Project: D-1170 19051.A01 - DVC Cadaver Lab
Diablo Valley College, Pleasant Hill, CA
KPW Project No. 19C231

Subject: Structural Study & Letter – RE: IR A-22

PARTIAL DEMO PLAN

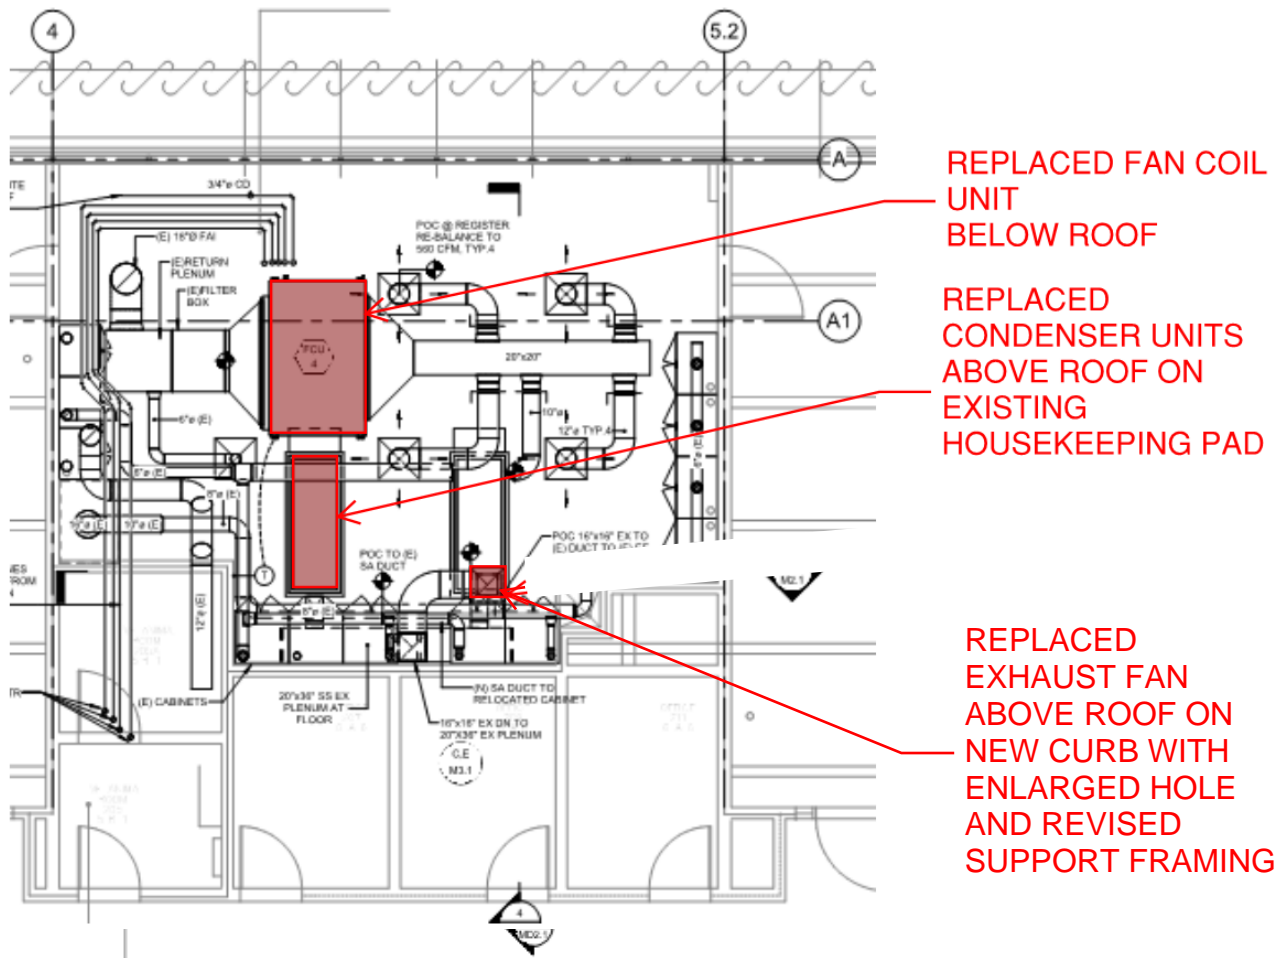
Condenser Pad support framing: The condenser pad is supported by 6x12 framing below the 2x decking. The 6x12 framing is adequate for the new replacement condenser units, which weigh 440 # (less than the 770# of the existing condenser units).

Fan Coil Unit support framing: The Fan coil unit is supported by Unistrut which is supported under 6x12 framing. The 6x12 framing would be approximately 3.5% overstressed under new loads which includes the 1,290 # fan coil unit. Comparatively, the 6x12 framing is 2.5% overstressed under the existing loads which includes 1,200 # existing fan coil unit).

Exhaust fan support framing: The fan is supported by framing and blocking below the 2x decking. The framing below is adequate for the new replacement fan loading, which weigh 80 # (less than the 120# of the existing fan unit). However, the opening would need to be larger, cutting more 2x decking, and in turn requiring reframing of the blocking below as well as the curb above for the enlarged hole size.

- The new fan coil unit is sized to not exceed the weight of the existing. This may be accommodated by further evaluation of the existing unit’s weight or by specifying a lighter new unit. The new fan coil unit should ideally be 1100# or lighter to bring the stress of the existing 6x12 support beams down to their code allowable levels.
- Size the ductwork of the new exhaust fan to match the existing
- Avoid new ductwork
- Avoid replacement of any ceiling tiles, grilles, electrical components, etc.

PARTIAL PROPOSED NEW PLAN

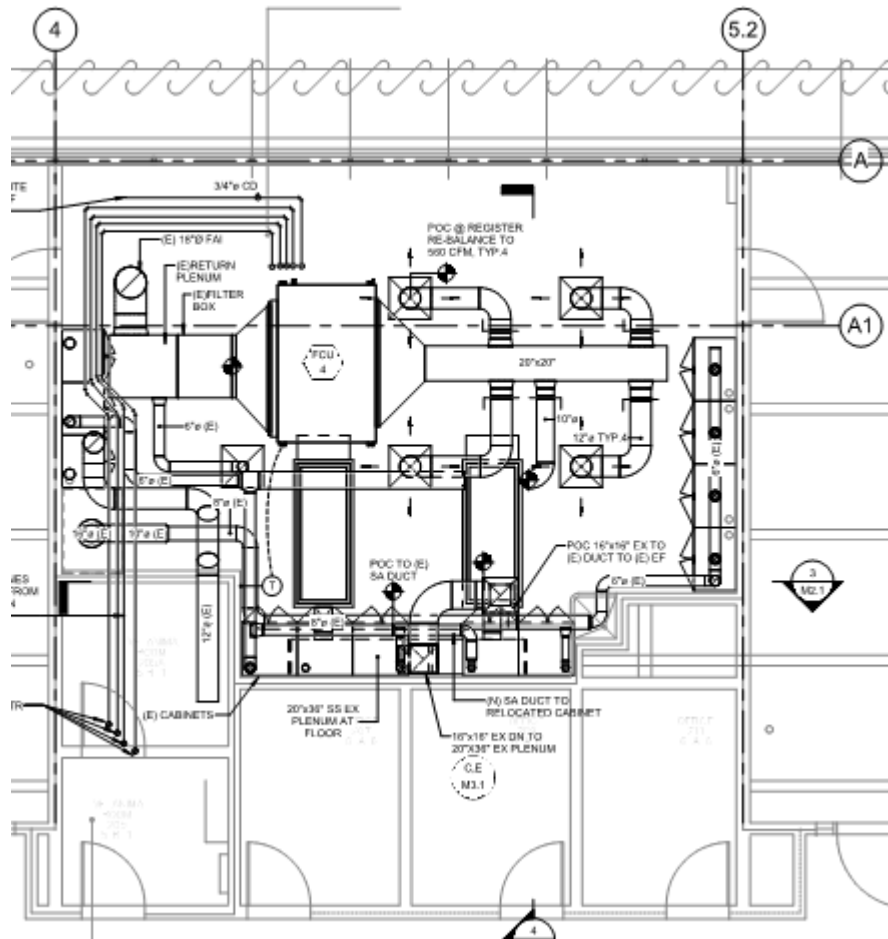
- The new Fan Coil unit is heavier than the existing. The location of the unit is slightly different, and its size and supporting Unistrut installation is slightly different.
- The framing that supports the new Fan Coil unit is currently slightly overstressed by code. Even the proposed marginal increase in Fan Coil unit weight further exacerbates the concern.
- The new exhaust fan ductwork is about 4” larger in each direction than the existing exhaust fan ductwork, and it will require enlarging the roof opening penetration through the 2x T&G decking, requiring framing and hangers below. This will require structural calculations, hanger callouts, and anchorage details, all subject to DSA SS review.
- New ductwork will be required.
